ADDENDUM NO. 2

RE: Indiana University Bloomington
BL000B Multi-Building - BL147, BL414, BL419
Renovate Multiple Restrooms

PROJECT No.: 20250532

DATE: February 27, 2026

BL147 MERRILL HALL
FIRST FLOOR
FLOOR PLAN

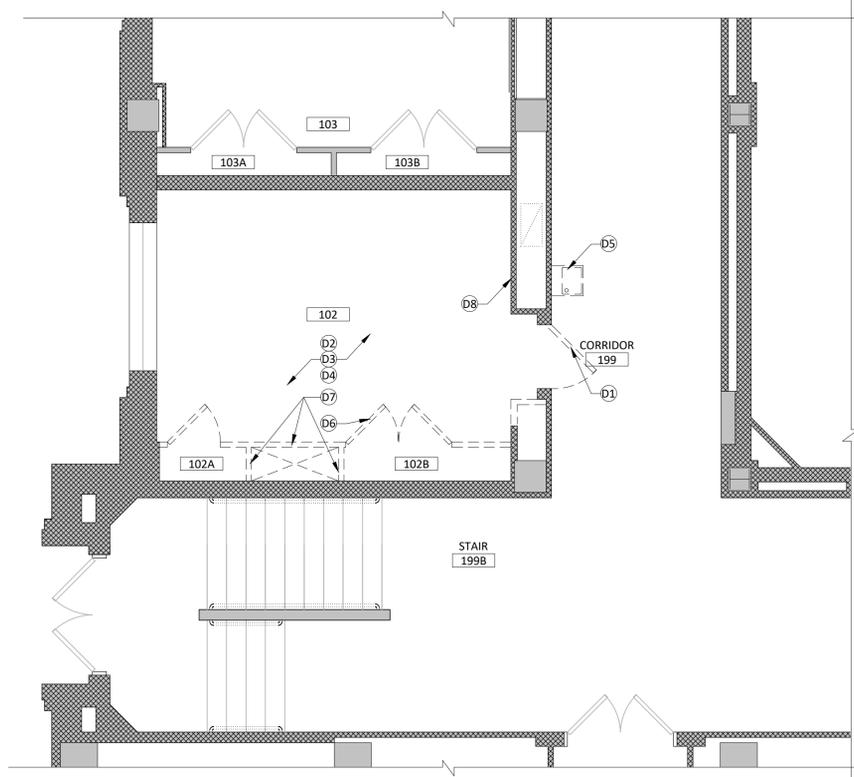
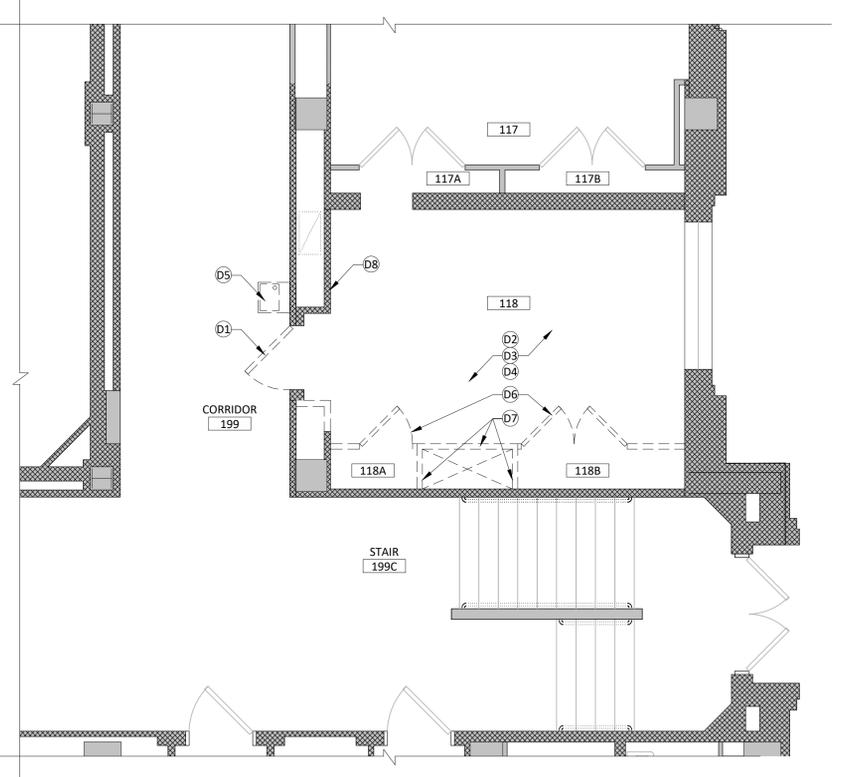
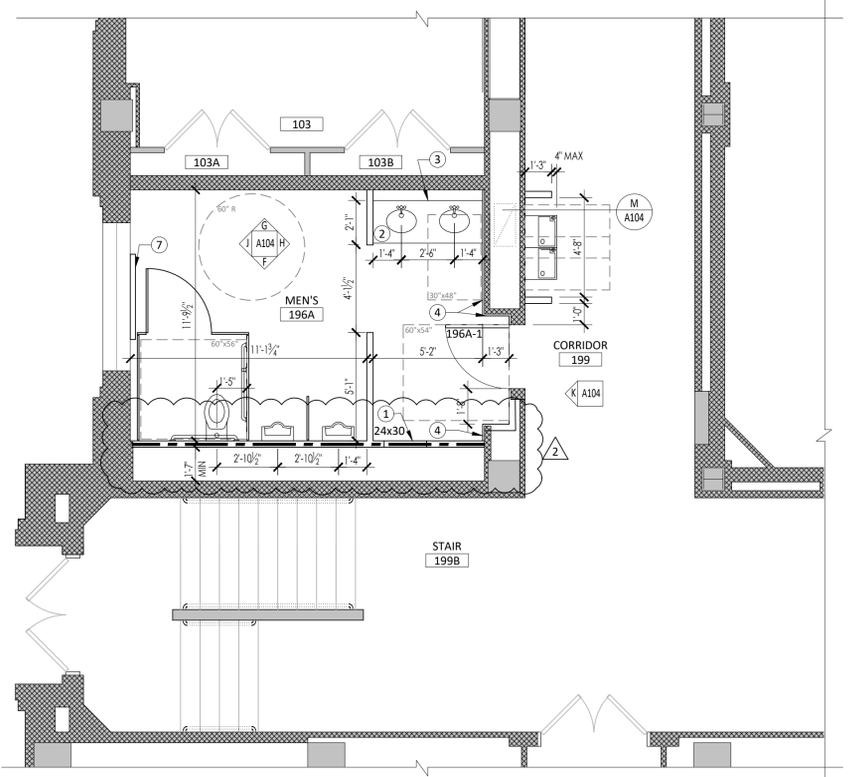
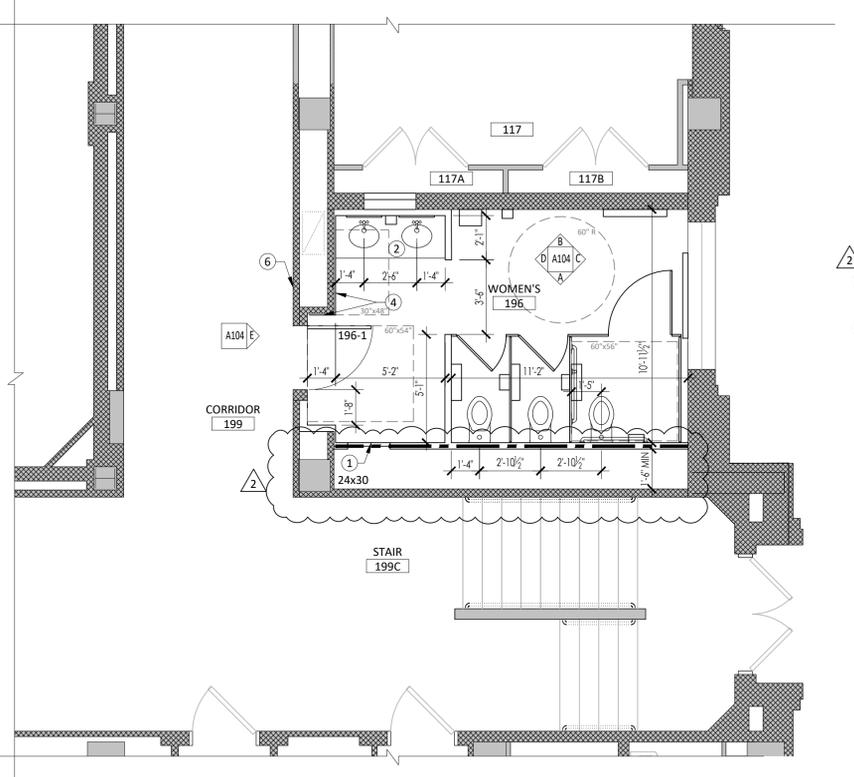
1. Sheet A101 – BL147 MERRILL HALL FIRST FLOOR FLOOR PLAN
 - a. Provide 1-hour rated shaft wall at South Wall at Women’s 196 and Men’s 196A, see attached.
2. Sheet A102 – BL147 MERRILL HALL FIRST FLOOR REF. CEILING PLAN
 - a. C/A102 CEILING DETAIL, revise per attached.
3. Sheet A111 – BL147 MERRILL HALL SECOND FLOOR FLOOR PLAN

BL147 MERRILL HALL
SECOND FLOOR
FLOOR PLAN

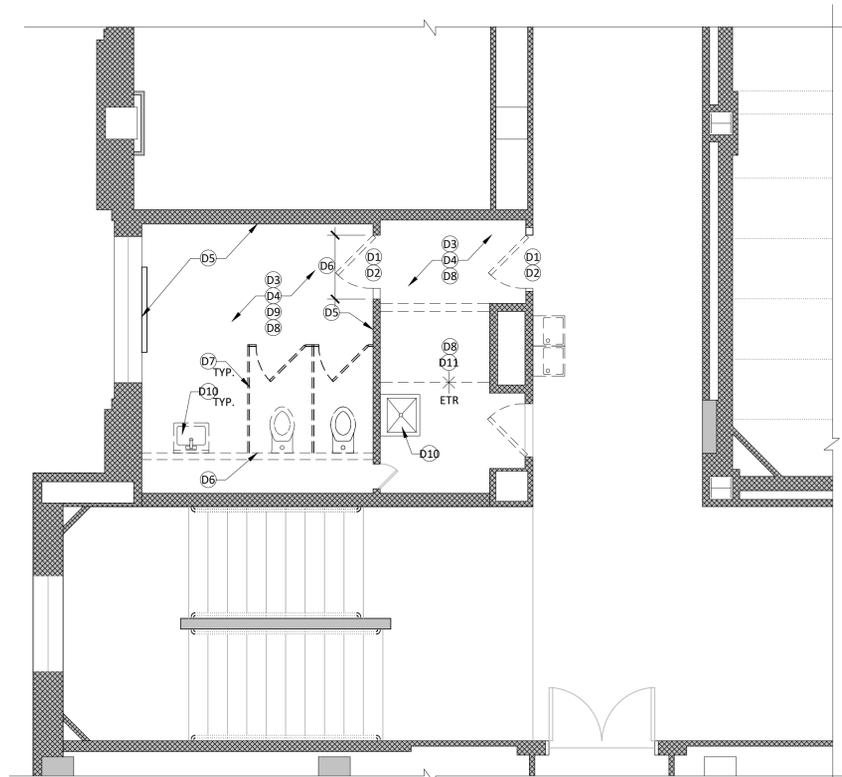
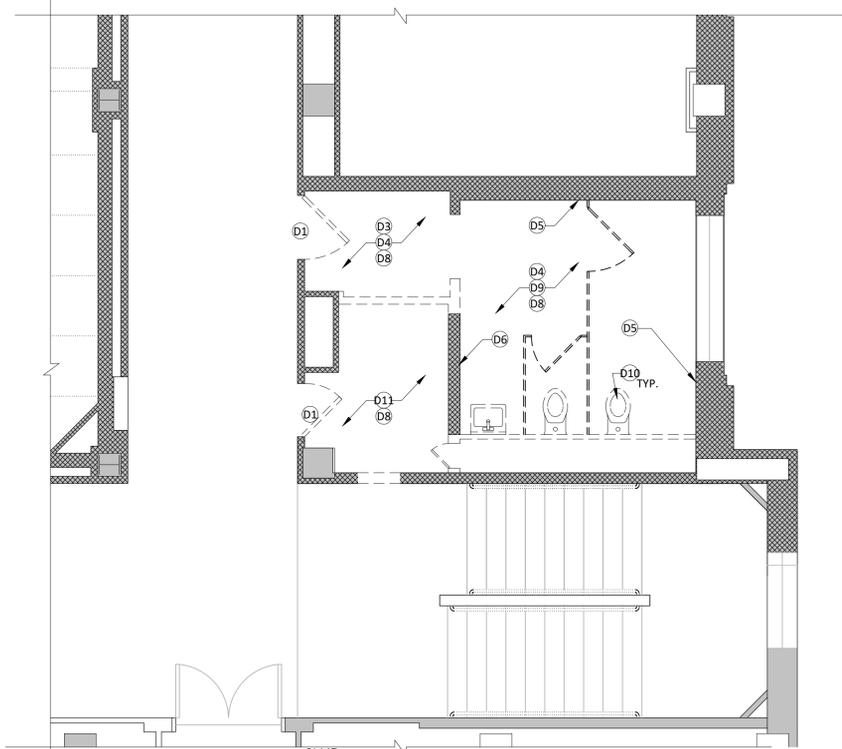
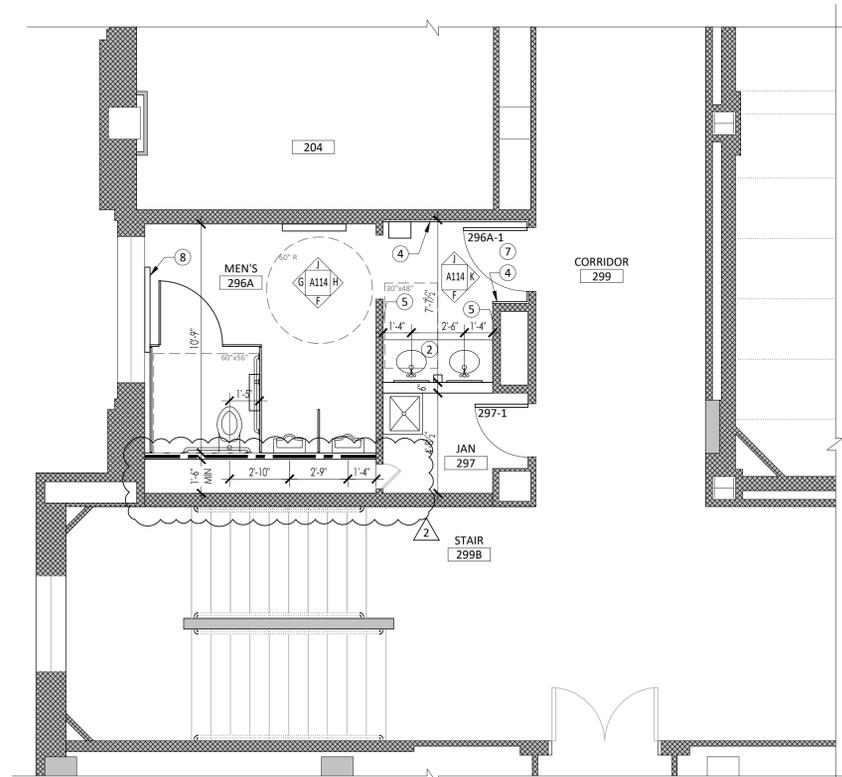
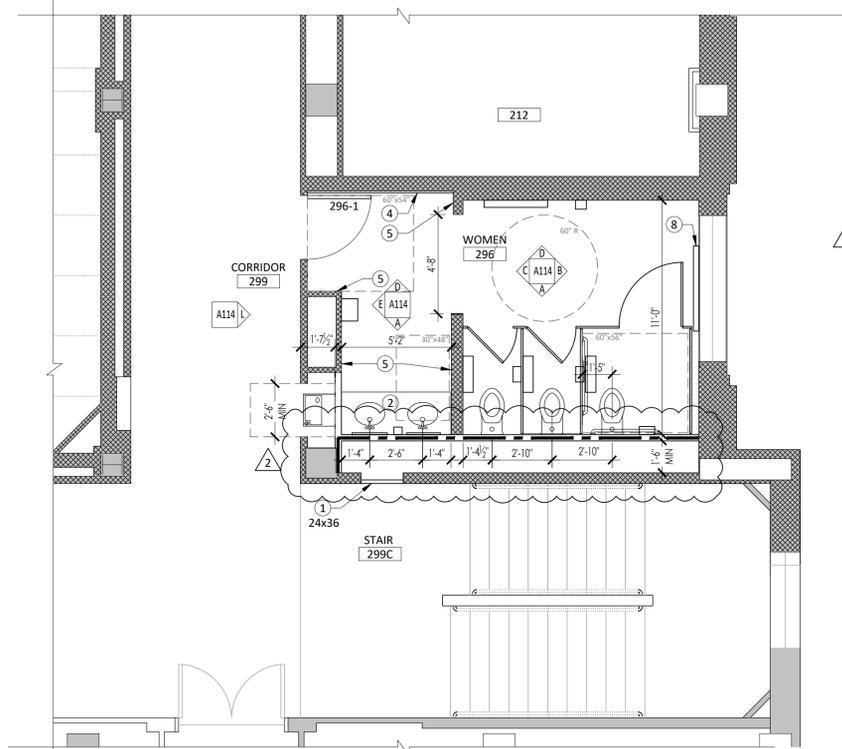
- a. Provide 1-hour rated shaft wall at South Wall at Women's 296 and Men's 296A, see attached.
4. Sheet A124 – BL414 MYLES BRAND HALL INTERIOR ELEVATIONS
 - a. J/A124 INTERIOR ELEV, revise per attached.
5. Sheet H101 – BL147 MERRILL HALL FIRST FLOOR HVAC PLANS
 - a. Add a fire damper at the chase wall penetration of the 12"x6" exhaust duct in both rooms 196 & 196A.
6. Sheet H111 – BL147 MERRILL HALL SECOND FLOOR HVAC PLANS
 - a. Add a fire damper at the chase wall penetration of the 12"x6" exhaust duct in both rooms 296 & 296A.
7. Sheet E111 – BL147 MERRILL HALL SECOND FLOOR ELECTRICAL PLANS
 - a. See attached revised plan.
